PLAN COMMISSION

Monday, March 15, 2021

- a. Public hearing regarding a Conditional Use Permit, requested by 5411 Bashford LLC - Dan Chin Homes, for three residential units as part of a proposed two-story mixed-use development at 5411 Bashford Street, McFarland, property zoned C-C Central Commercial.

Re: Review of 5411 Bashford Street Site Plan

SITE PLAN

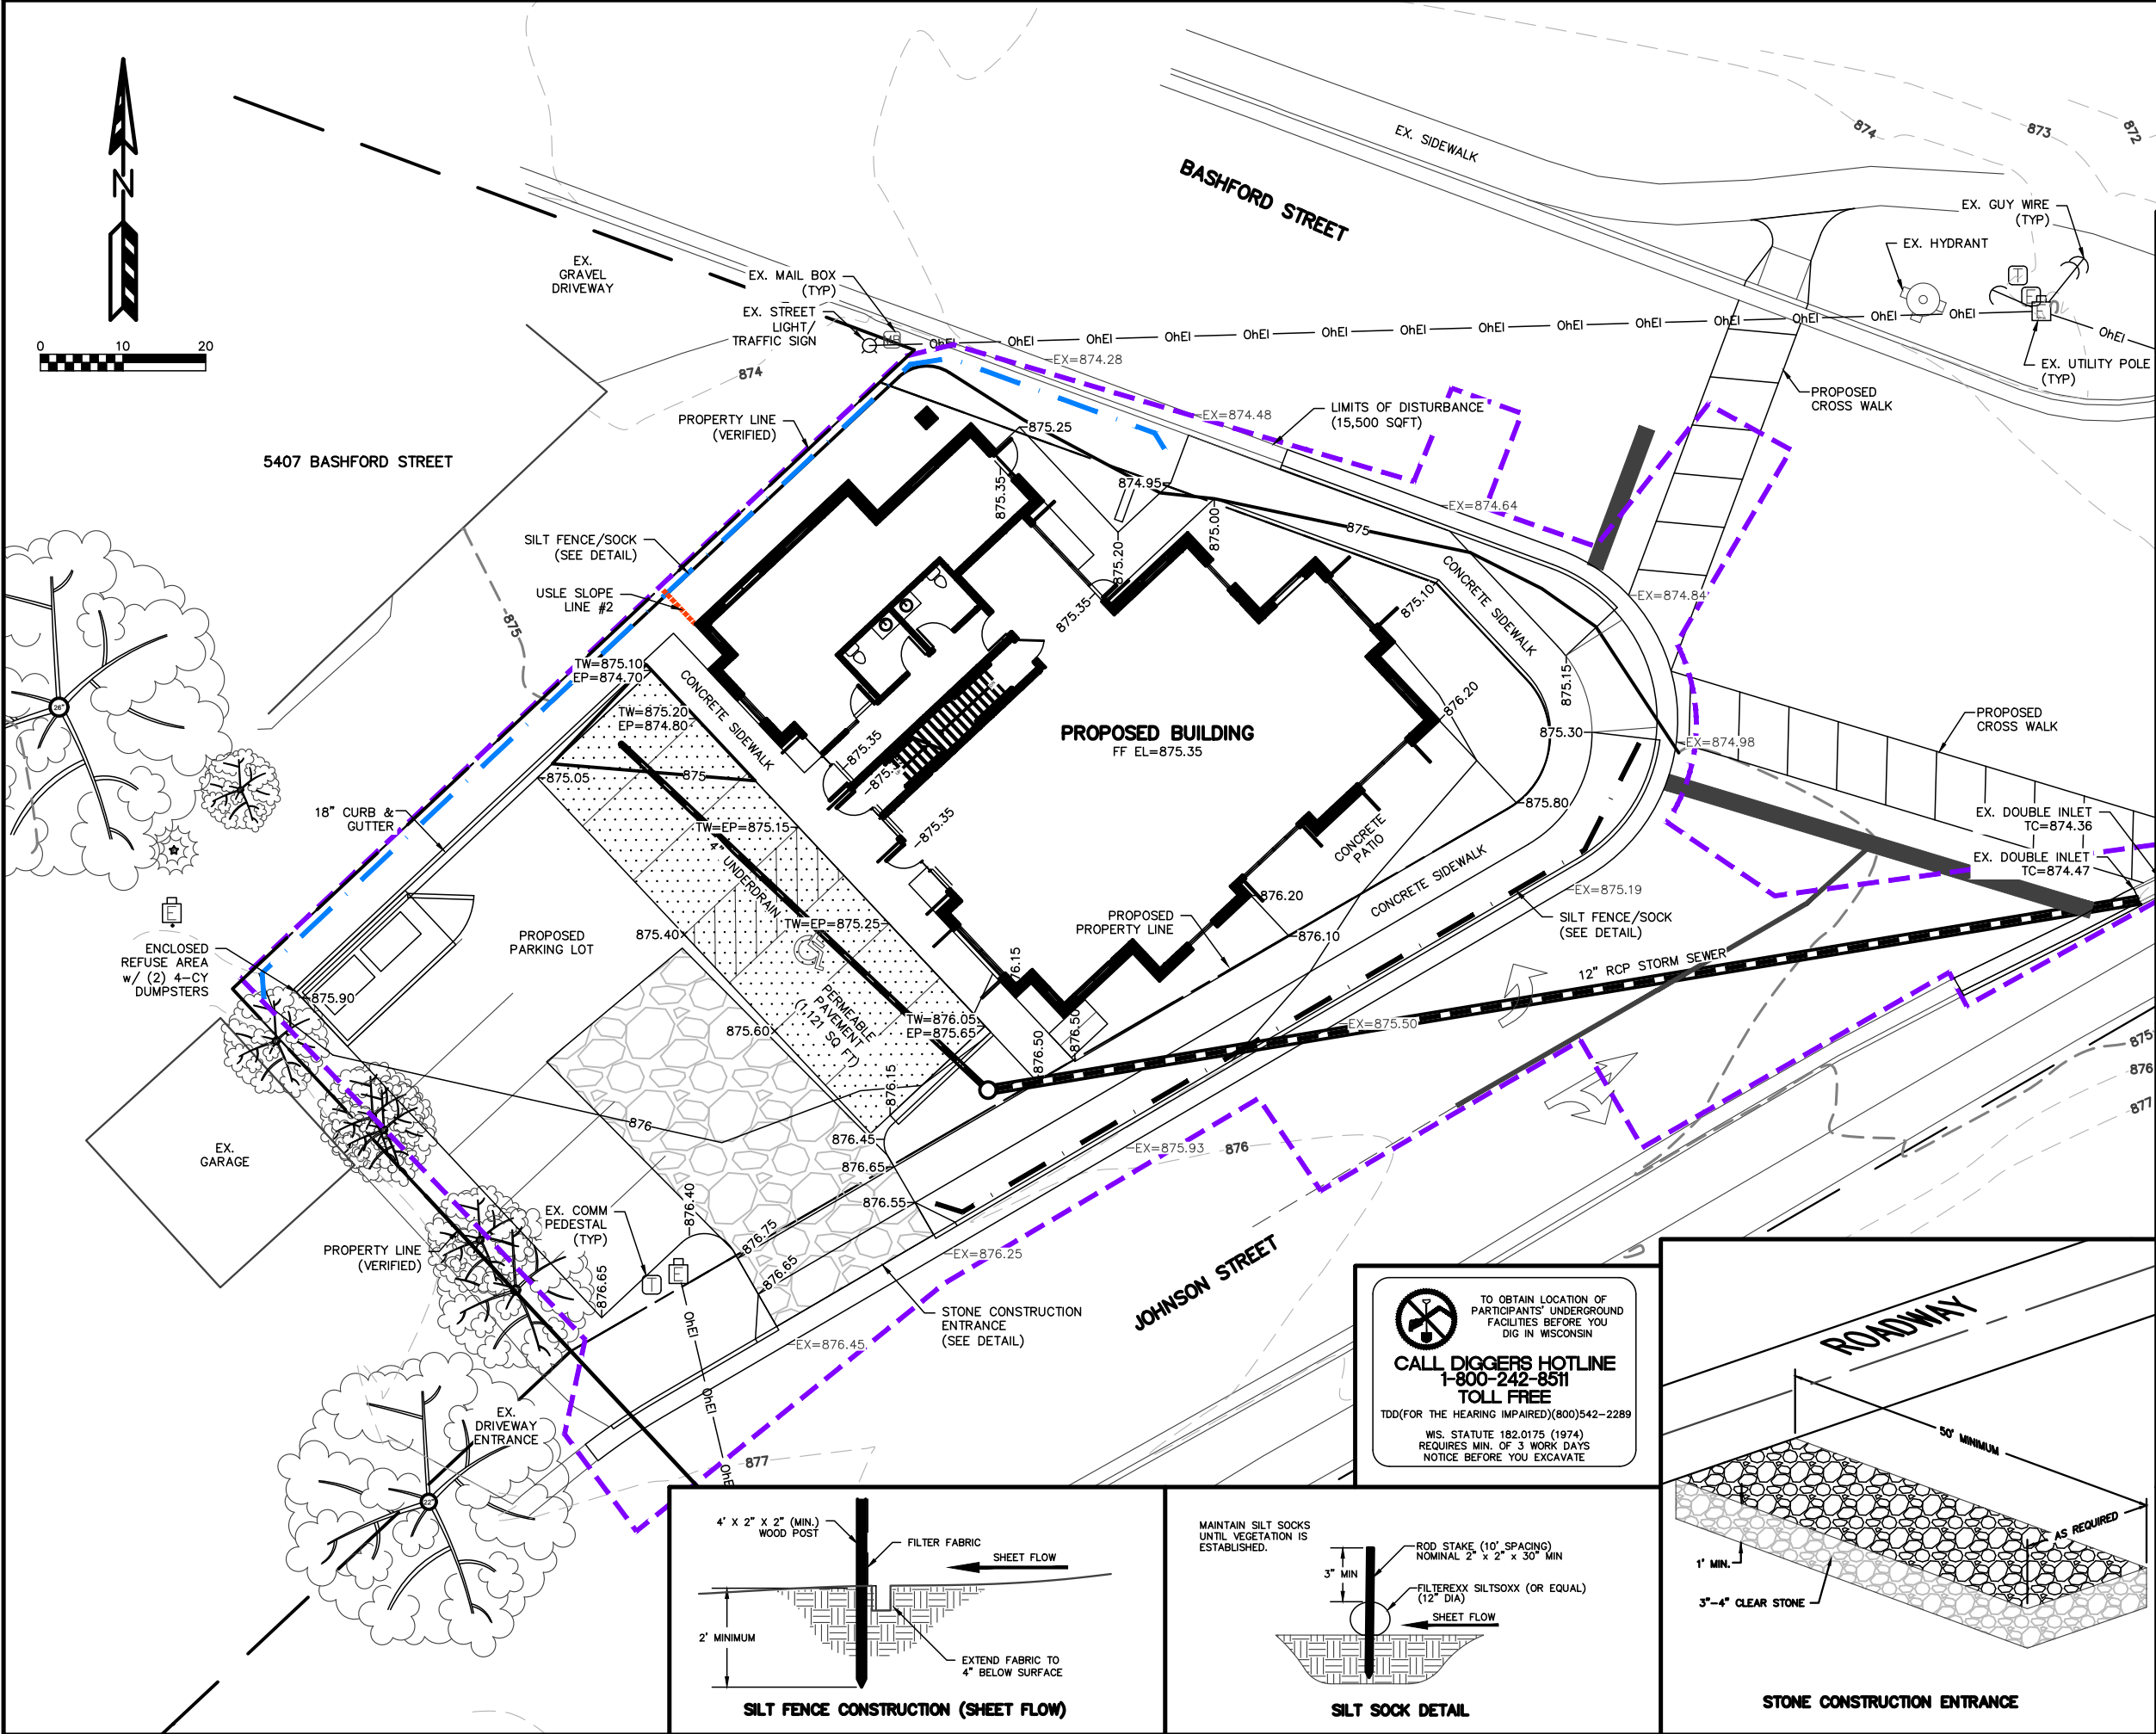
- **Landscaping.** Per Sec. 62-72, there are no minimum landscaping points required in the C-C District. The proposed landscaping plan provides for landscaping in an amount that would be close to satisfying the minimum landscaping points if the project were otherwise located in the C-G District. The plan also includes the preservation of existing trees along the rear lot line to aid in screening the parking lot from the adjacent duplex (6004-06 Johnson Street). Additional shrubs or solid fencing around the parking lot could be considered for additional screening purposes. Strategic locations for potential additional shrubs to minimize vehicular headlights on adjacent properties include at the end of the drive aisle and the first three stalls on the rear lot line.

- **Off Street Parking.** Per Sec. 62-172(j), off-street parking requirements are advisory only in the C-C District. The site design includes 11 off-street parking spaces. If the property were located within a residential district, a minimum of two stalls are required for each two-bedroom unit. If the property were located in another commercial district, a minimum of one stall per 300 square feet of floor area would be required, or nine stalls, or a total of 15 stalls for the entire development. The proposed site plan can accommodate the off-street parking needs of the residential units while providing a surplus of five parking stalls for general purpose use. As a mixed use development, the peak time periods for each use differ providing opportunities for greater shared use of the parking stalls, as supported by the TID #4 Design Guidelines. In addition, the public parking lot across Bashford Street provides additional parking availability for the commercial businesses. Some on-street parking is available along Bashford street and limited to non-school hours (7:30am-4:30pm) on Johnson Street. The travel lane between the row of parking stalls is 20', narrower than the typical 24 feet for two-way

90-degree parking; however, given the size and anticipated parking needs of the site, 20 feet should be acceptable. One concern with the proposed parking lot design is the availability for winter snow storage without impacting surrounding properties. The parking lot does meet the minimum setback requirements (5-feet) from the side and rear lot lines; however, this may not provide adequate snow storage space. There are a couple of alternatives to address this concern:

- The property owner could commit to hauling snow away.
 - The property owner could reduce the size of the parking lot by one or two spaces, adding additional green space on the north and/or south side of the parking lot for additional green space for summer use by the tenants and winter use for snow storage. The additional buffer yard to 5407 Bashford Street would also allow for planting a few medium evergreens end the end of the drive aisle to shield vehicle headlights as they pull into the parking lot.
